TOWN OF BAY HARBOR ISLANDS
DEVELOPMENT & REVIEW COMMITTEE MEETING
THURSDAY, APRIL 13, 2023

AGENDA ITEM REPORT
April 13, 2023

TOWN OF BAY HARBOR ISLANDS COMMUNITY DEVELOPMENT MEMORANDUM

Subject: Site Development Plan Application – 2023 Revisions (#3 DRC Review)
1177 Kane Concourse Mixed Use Development
Decrease DU from 90 to 54 / 98,046 Sq. Ft. Office / 15,525 Sq. Ft. Comm.
Bay Harbor Islands Acct. No. SPR23-000005
MMPA Acct. No. 01-0702-1063C

Date	02-23-2023	Sheet No.	A2.00
Scale			
Project	2234

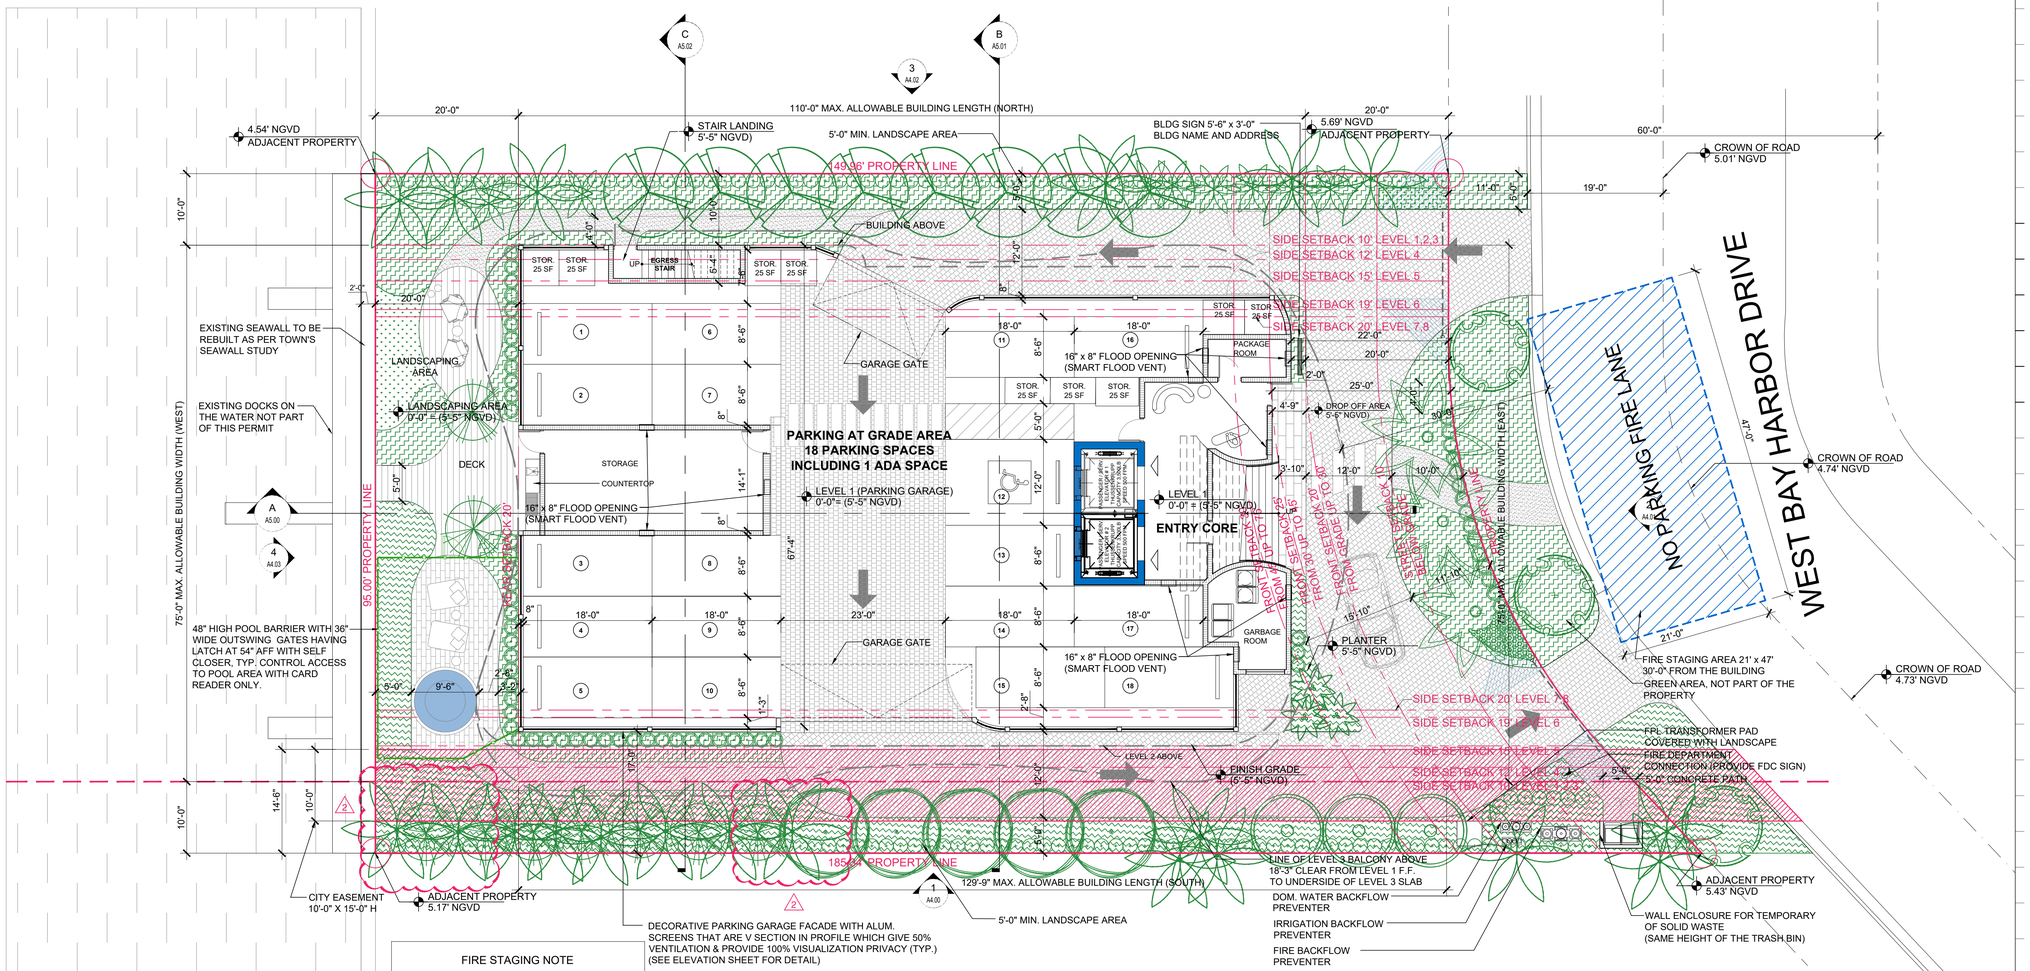
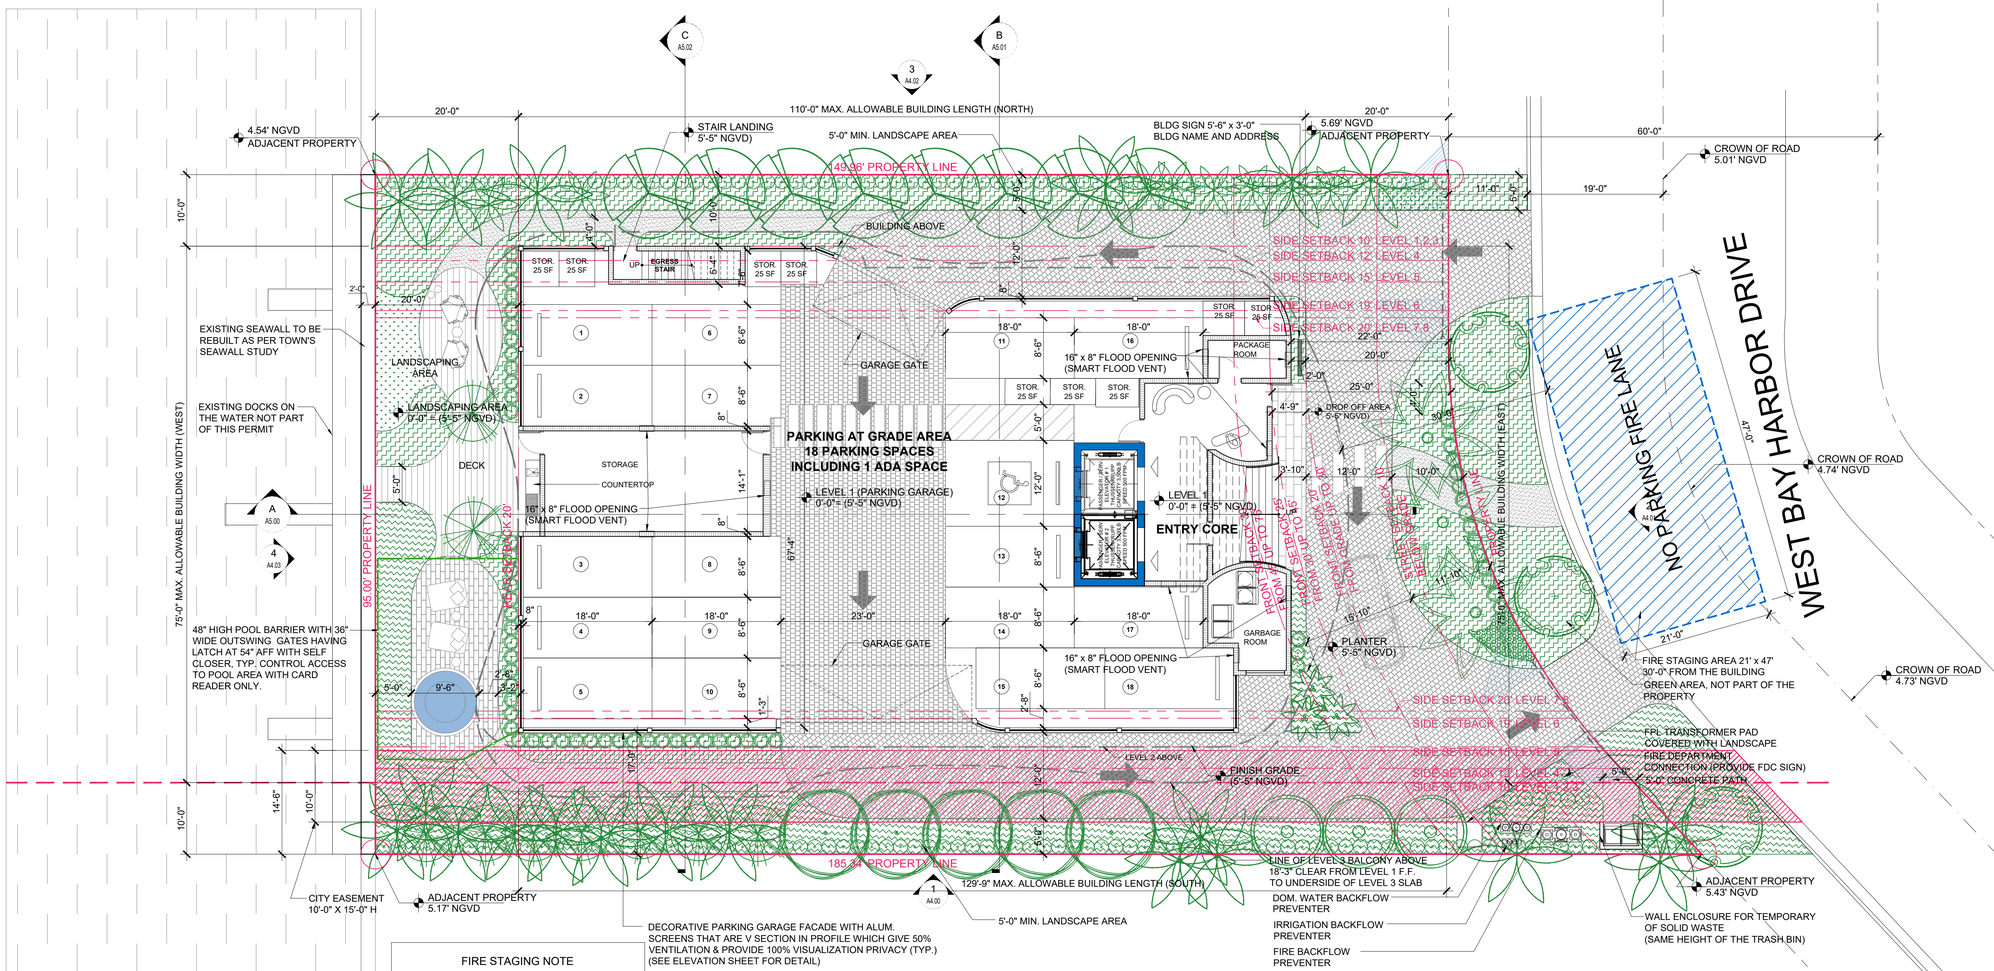
1) Sheet A2.00 has the following issues:
    a) Sec. 23-9(4) requires one storage area per unit (7 required). Each storage area must be at least 25 square feet in size with at least 7-feet of clear headroom. The storage areas are shown within the parking garage – but the location was modified (OK). A note was added as requested addressing the 7' headroom requirement.

ARCHITECTURAL (KOBI KARP)	2) Sheet A2.00 has the following issues:	
	2 a) Sec. 23-9(4) requires one storage area per unit (7 required). Each storage area must be at least 25 square feet in size with at least 7-feet of clear headroom. The storage areas are shown within the parking garage. Please note on the plans that at least 7-feet clear headroom will be provided for the storage units.	Refer to Sheets A2.00 and A3.02. Storage areas are at least 25 square feet, and provide at least 7' of clear headroom.
	2 b) Provide information on the type of fence proposed ,around the perimeter of the site. Plan states only 5' fence. What type of fence is proposed? Provide the color and material of the fence. A detail is required. The plans (site / civil) do not show a retaining wall. If a retaining wall is proposed clearly state so and provide a detail - ORB must approve the design. If such a wall is desired later the ORB will need to review / approve it.	Refer to Sheet A4.00. Aluminum wood grain colored fence is being proposed.

Date	02-23-2023	Sheet No.
Scale		A3.01
Project	2234

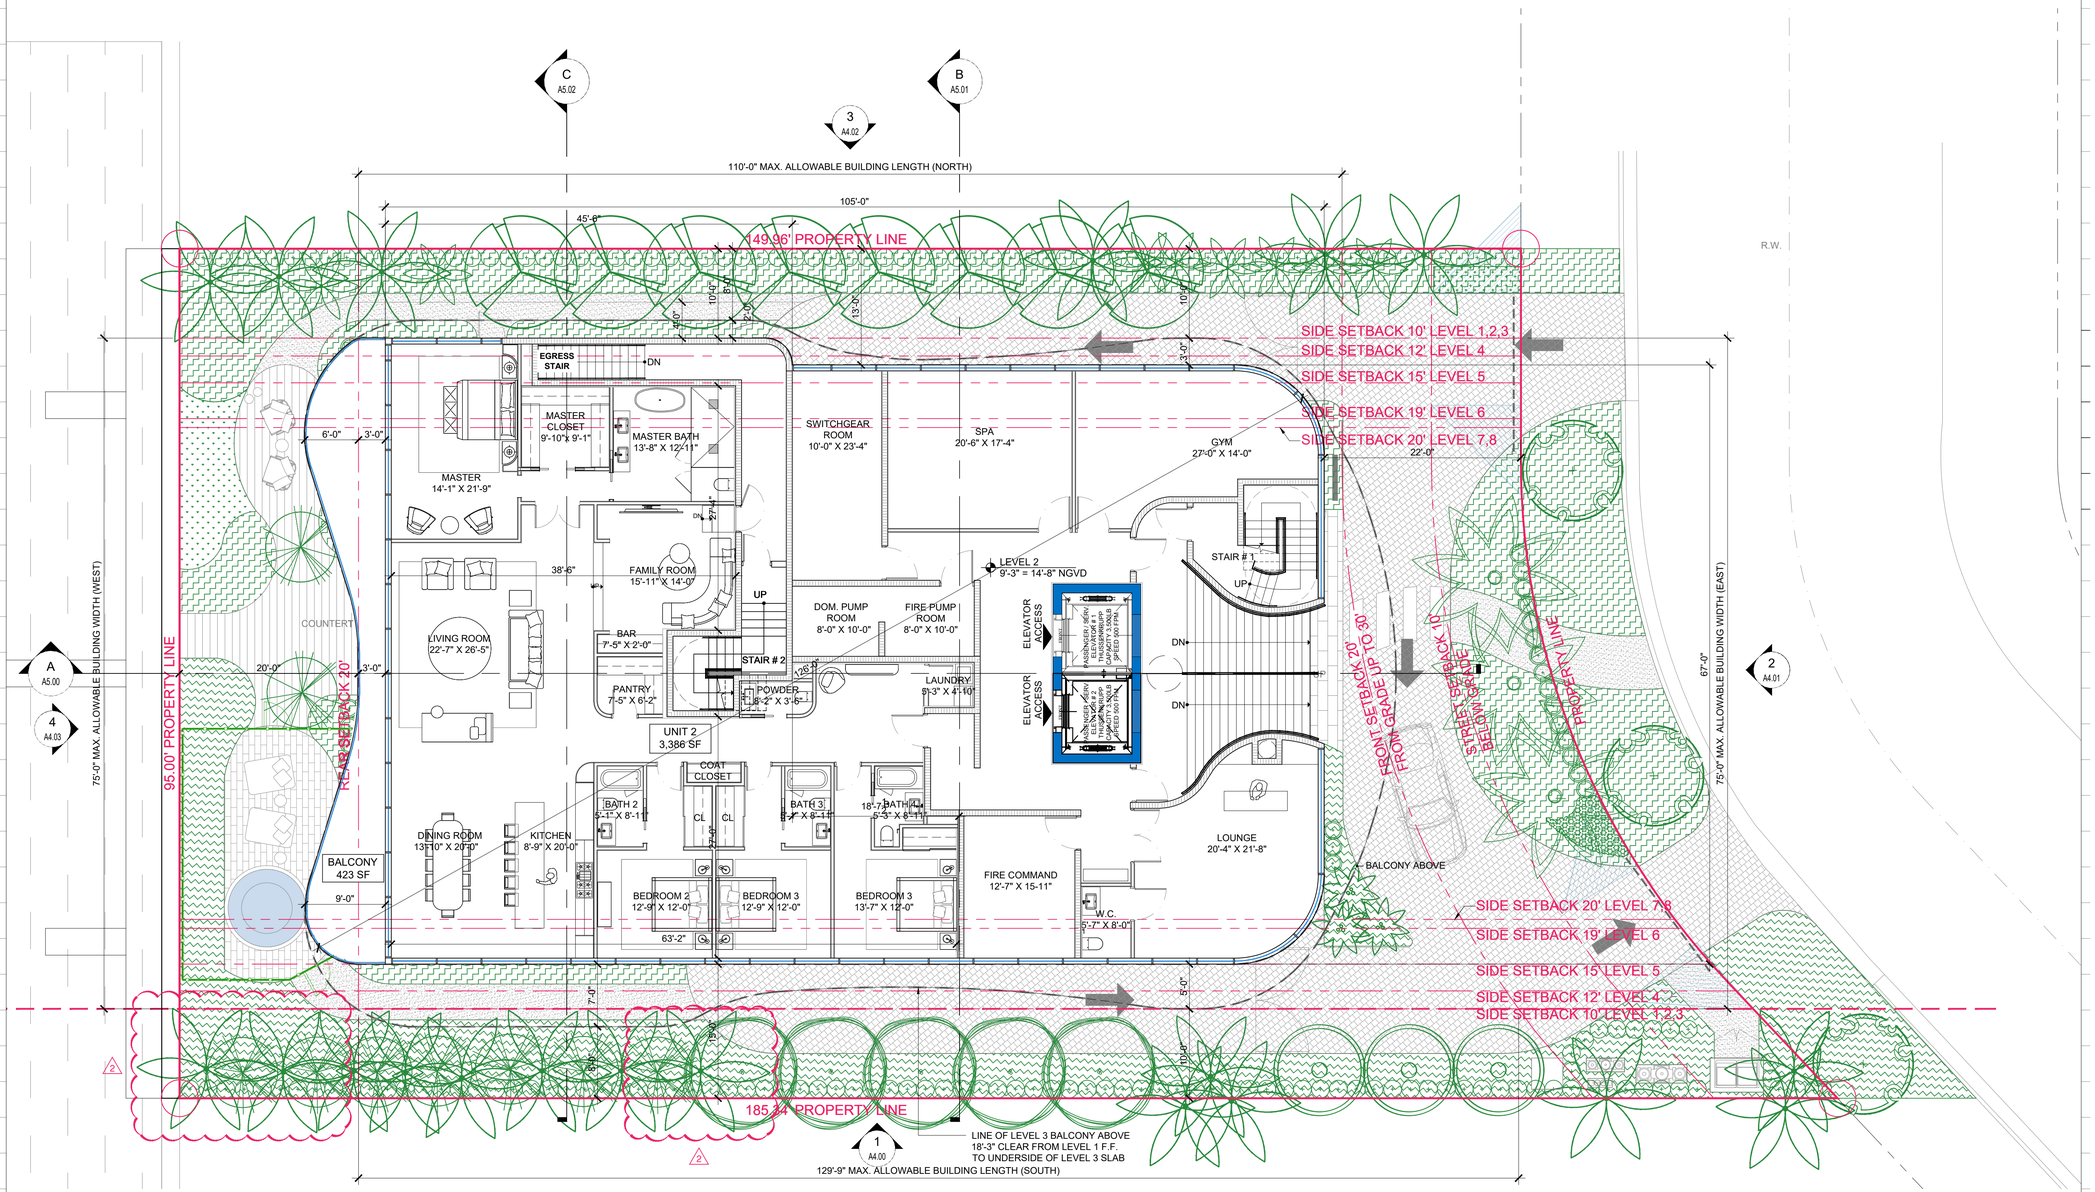
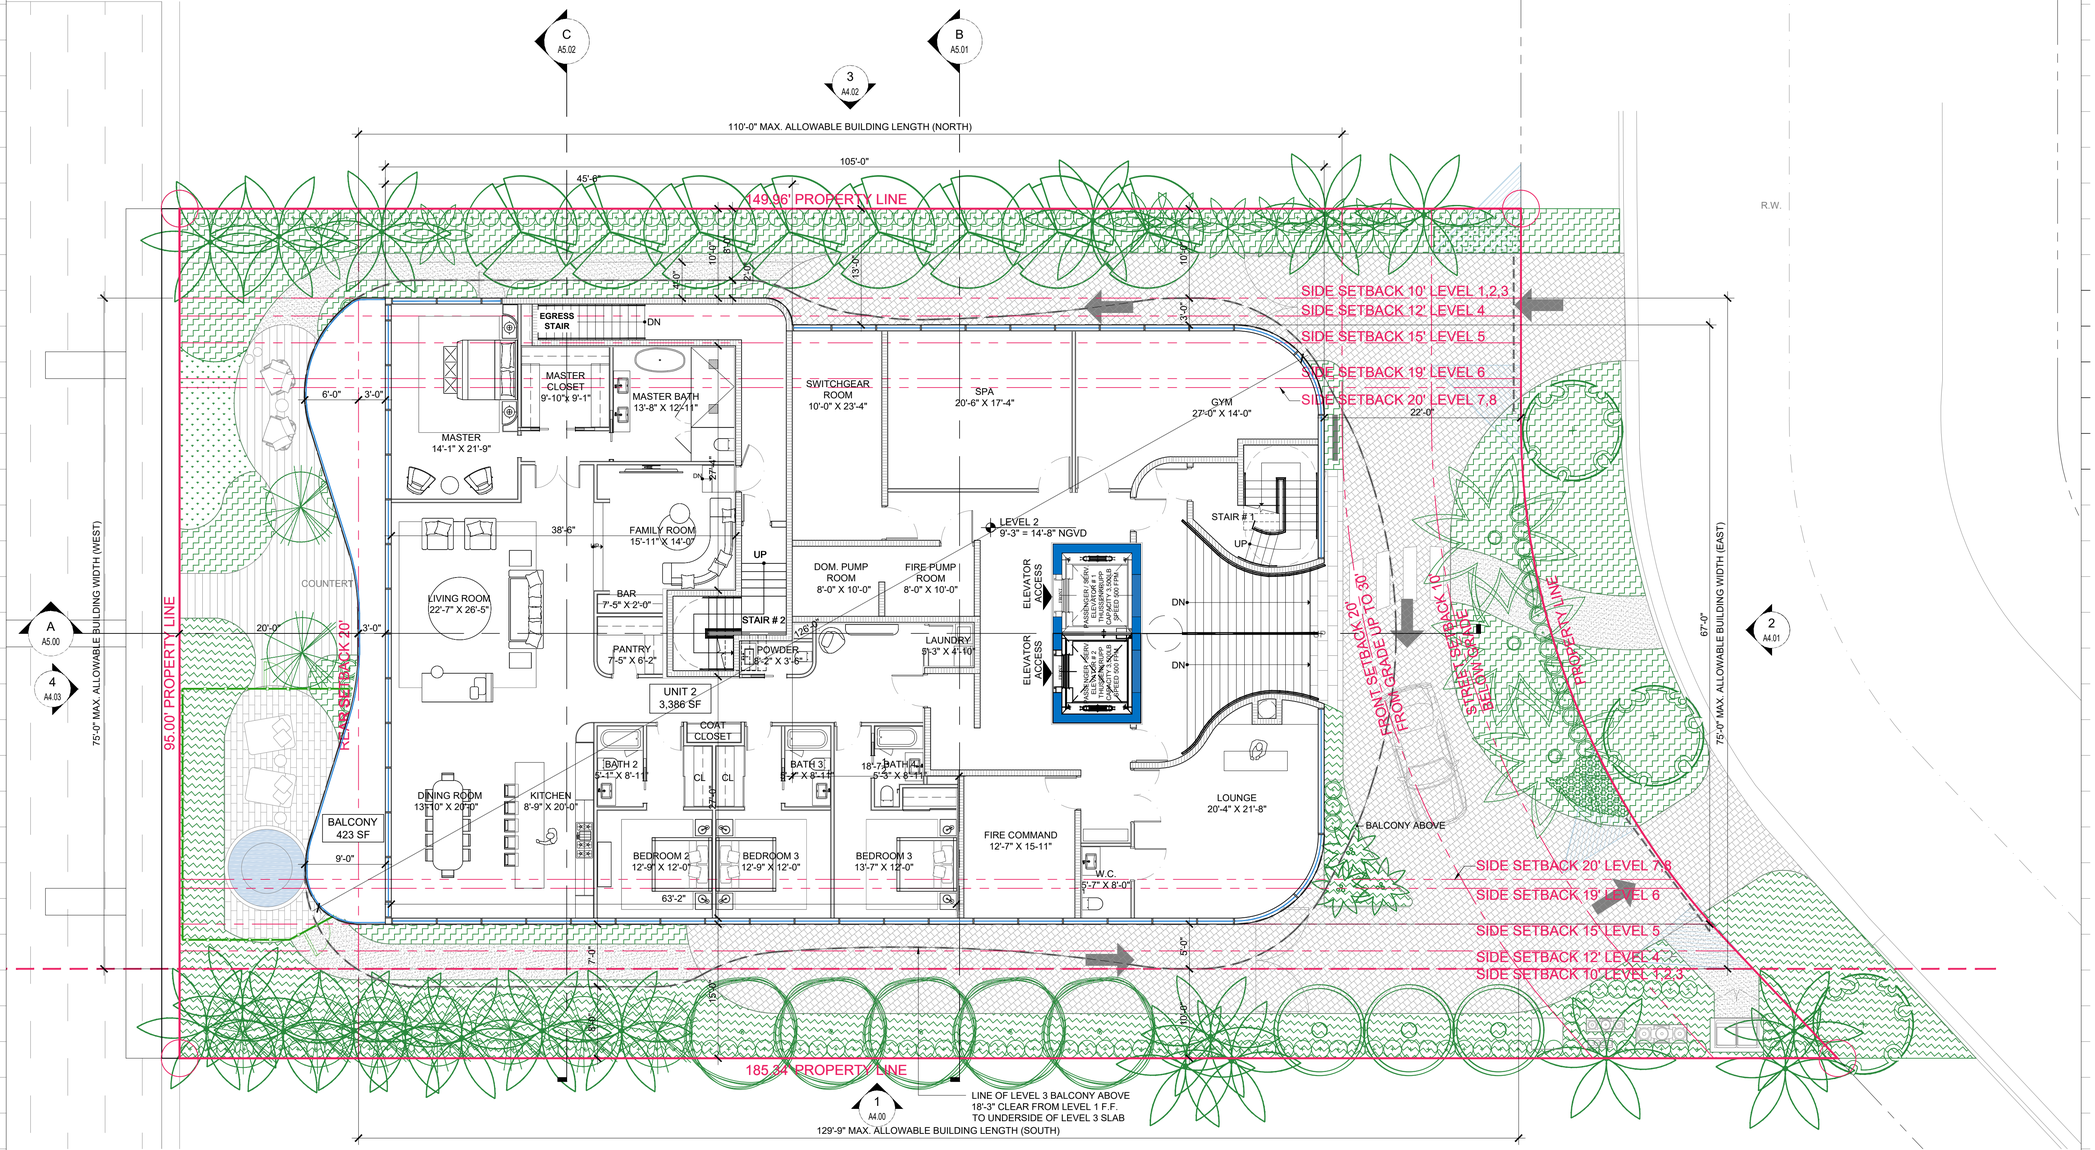
ARCHITECTURAL (KOBI KARP)	5) On Sheet A3.01 Unit 2a is listed as 3,368 square feet - it Is also listed as 3,380 square feet on the same sheet. Please confirm - possibly a typo.	Refer to Sheets A1.00 and A3.01. All unit sizes have been coordinated.
